**BOARD ACTION REPORT – APPEALABLE ITEM**

**Project Name:** Paradise Sports Lounge Class III (5155 W. Atlantic Avenue)  
**Project Location:** 5155 W. Atlantic Avenue  
**Request:** Approval of a Class III (Outdoor Seating)  
**Board:** Site Plan Review and Appearance Board  
**Meeting Date:** October 11, 2017

**ITEM:** **Paradise Sports Lounge (2017-201) (5155 W. Atlantic Avenue):** Class III Site Plan Modification associated with the addition of 1,535 SF of outdoor seating area.

BUILDING  
ELEVATIONS

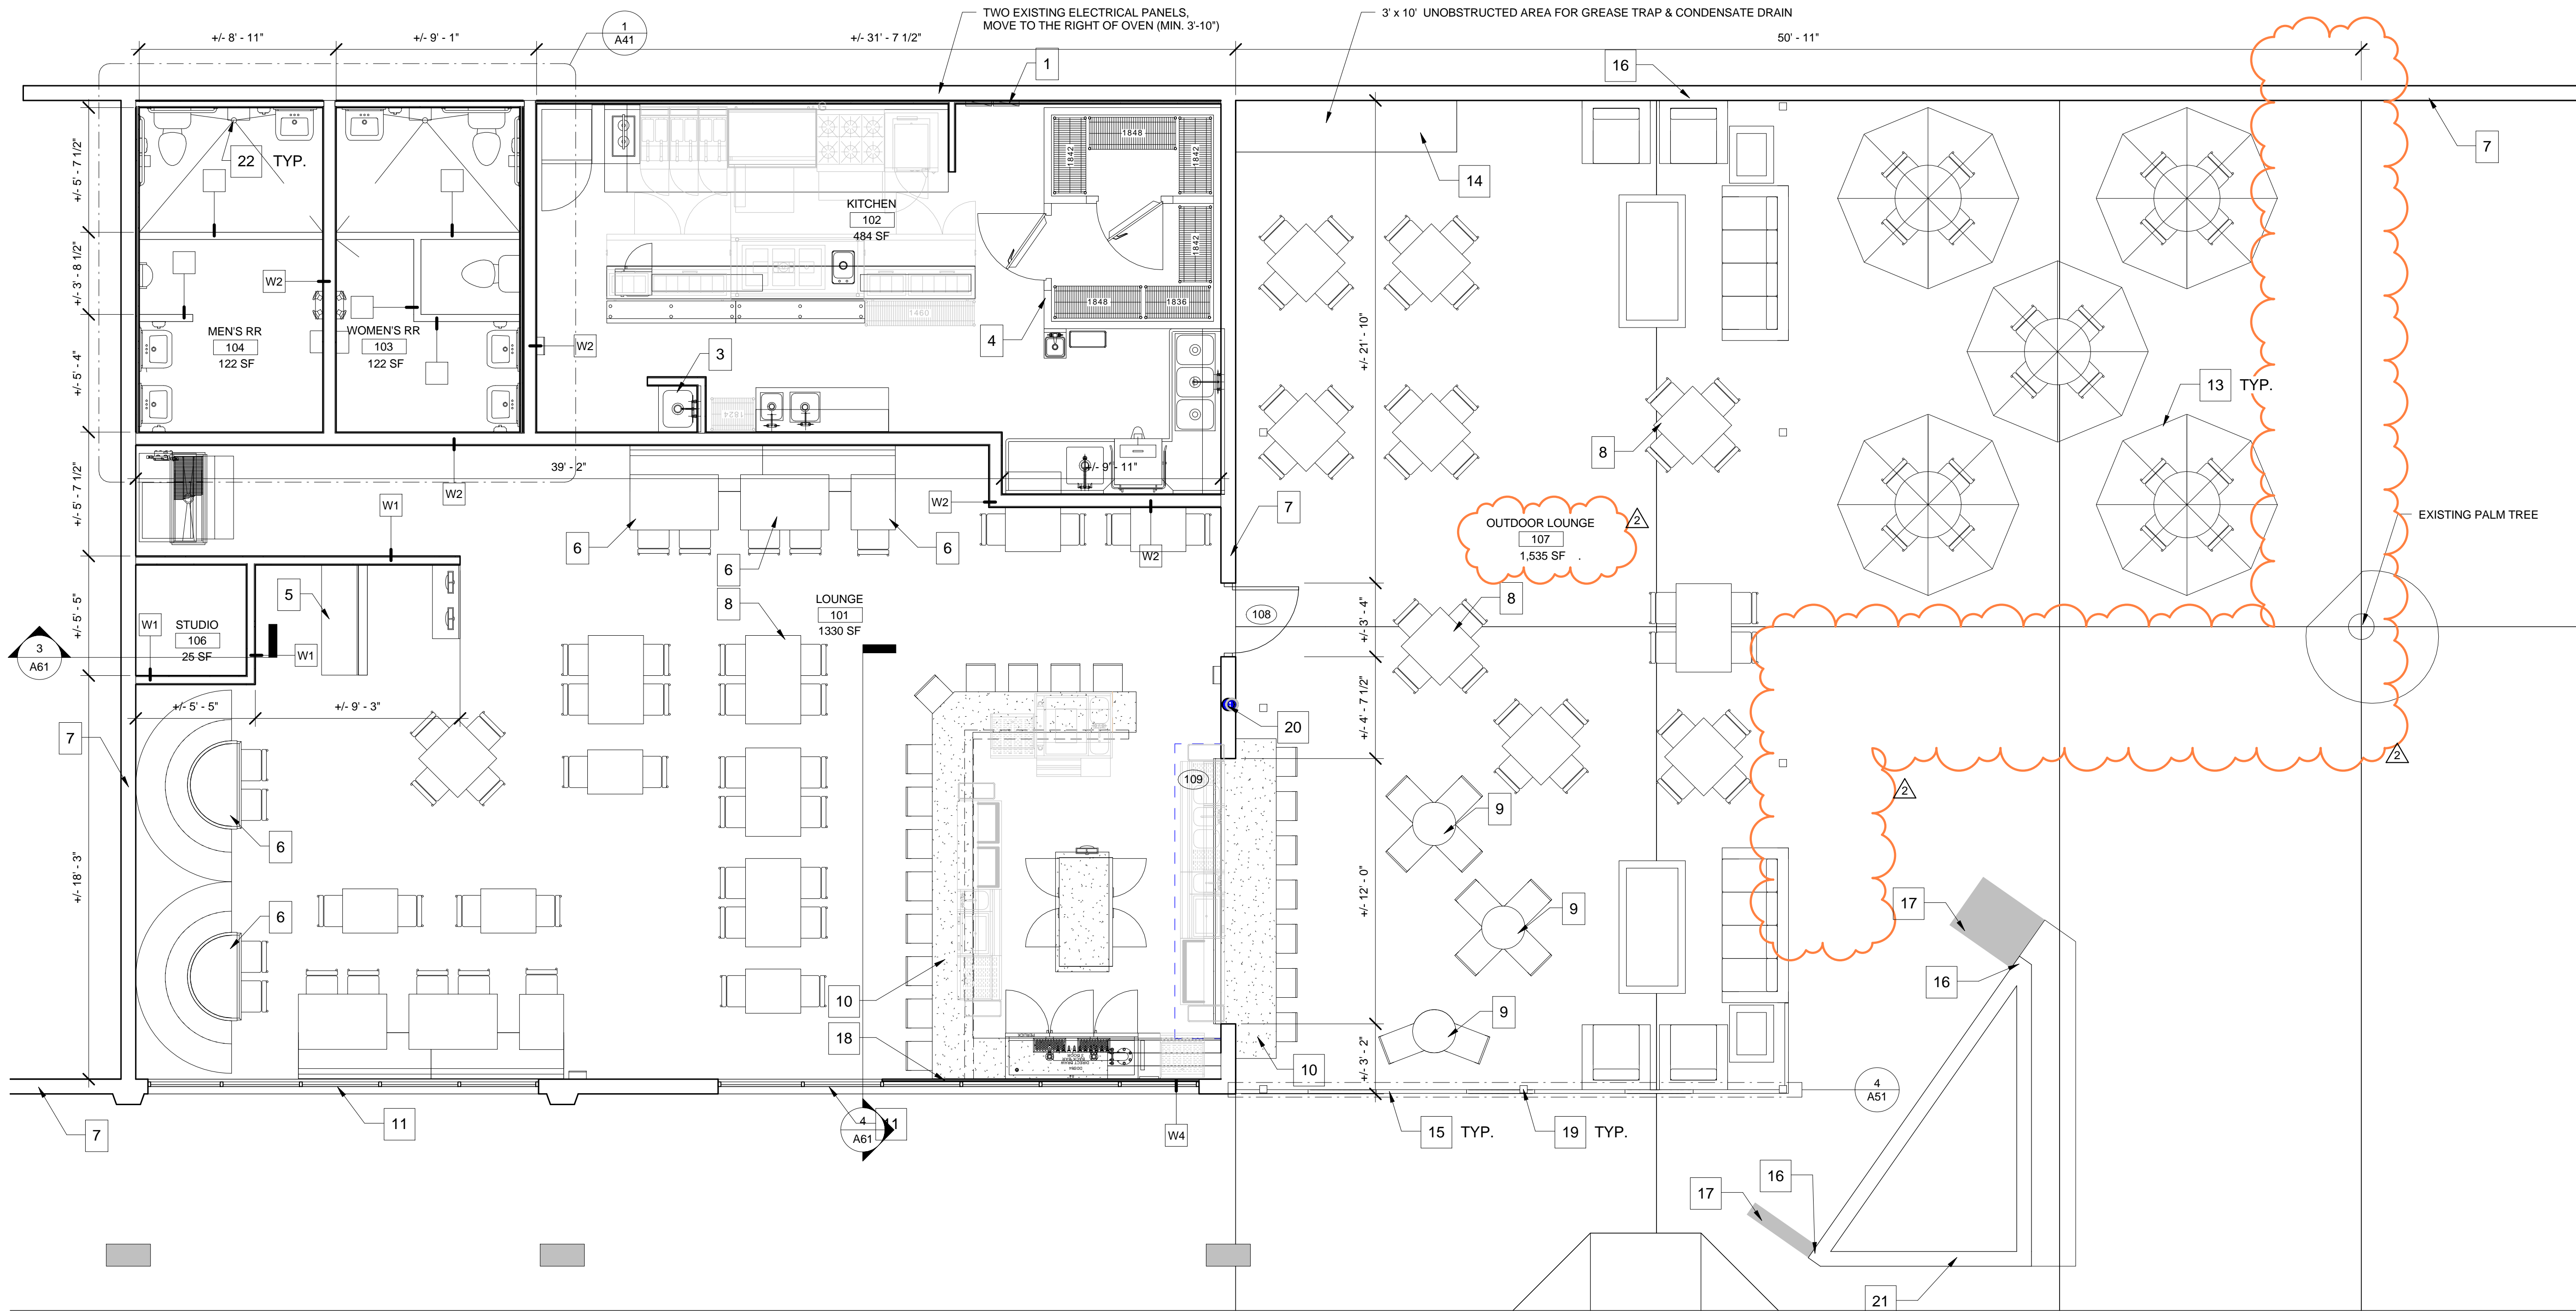
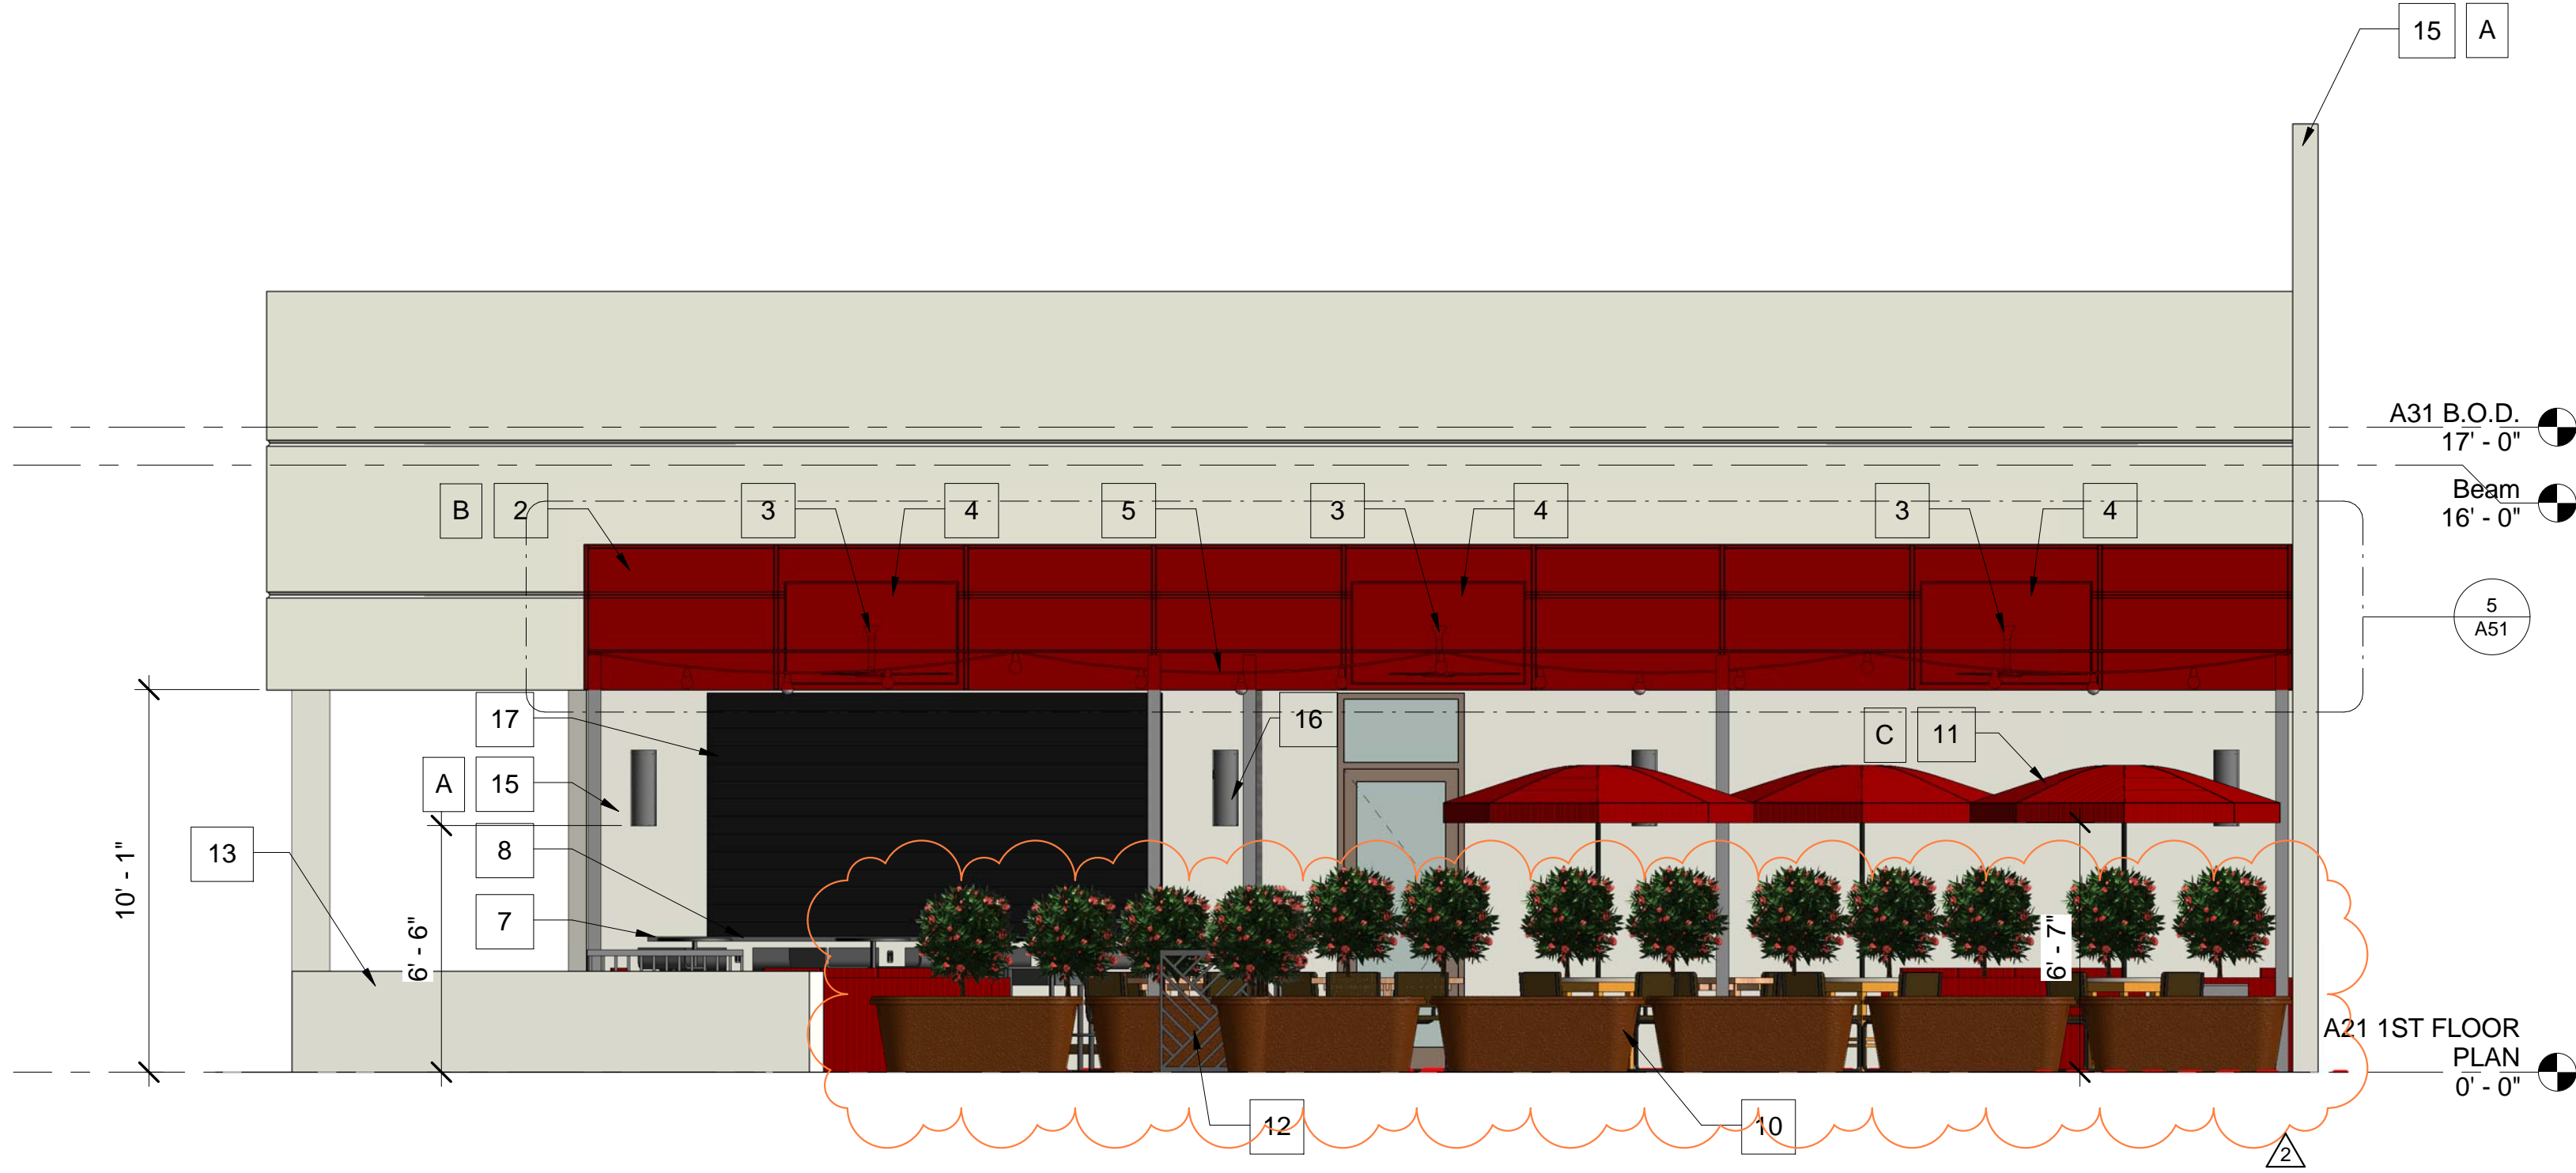
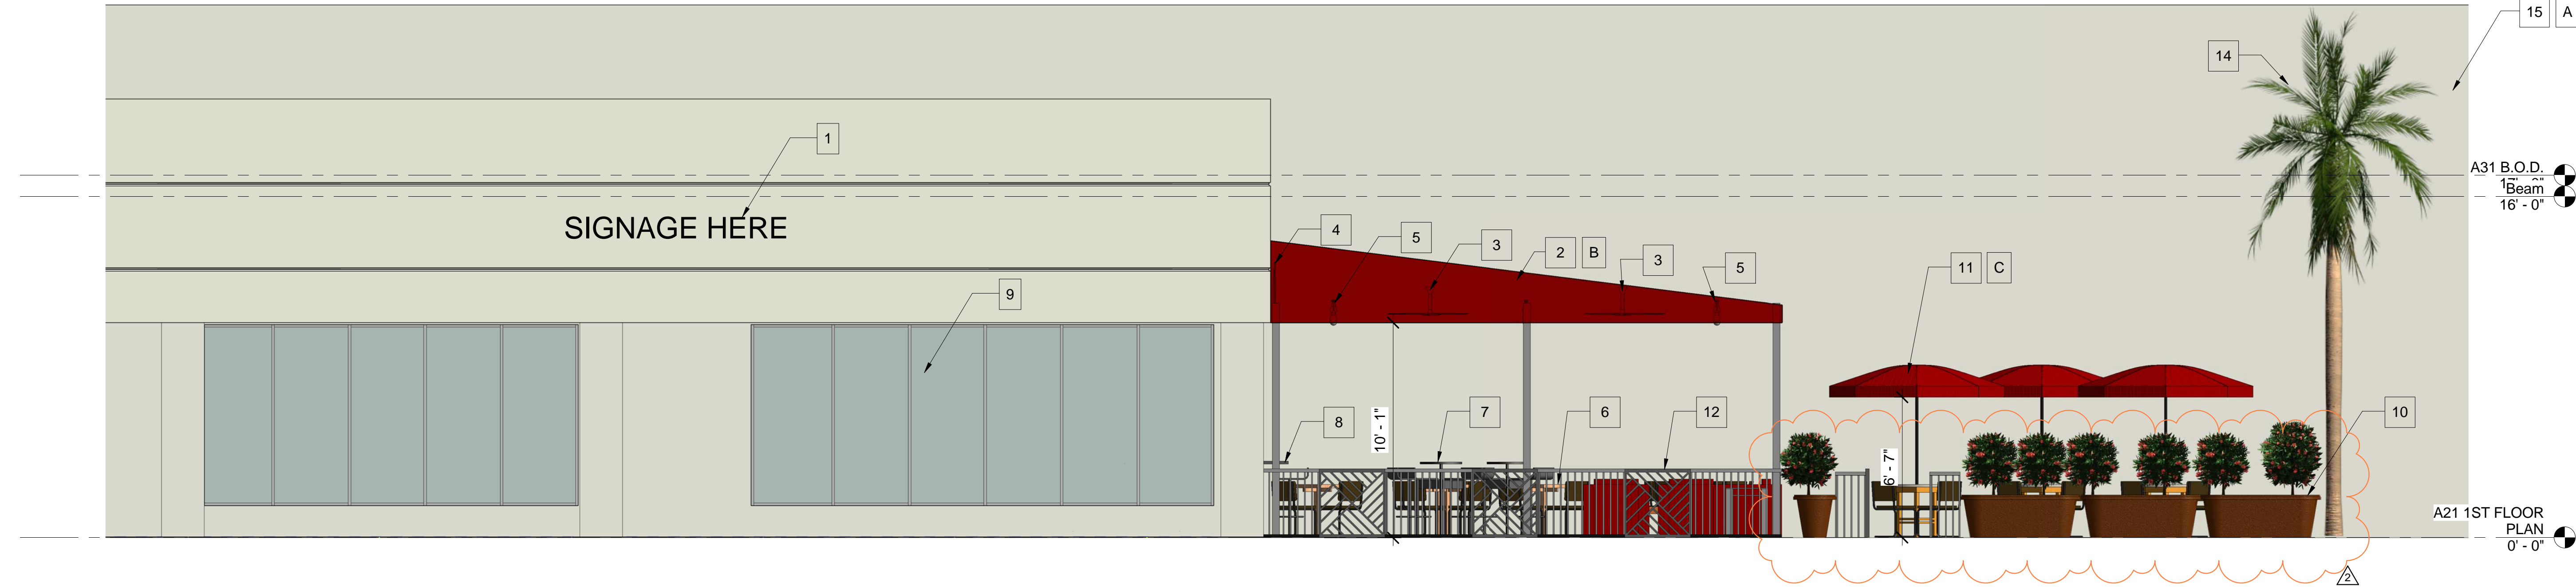
1. The traffic statement from Palm Beach County is submitted prior to issuance of a building permit.
2. The planters are removed from the building elevations prior to site plan certification.
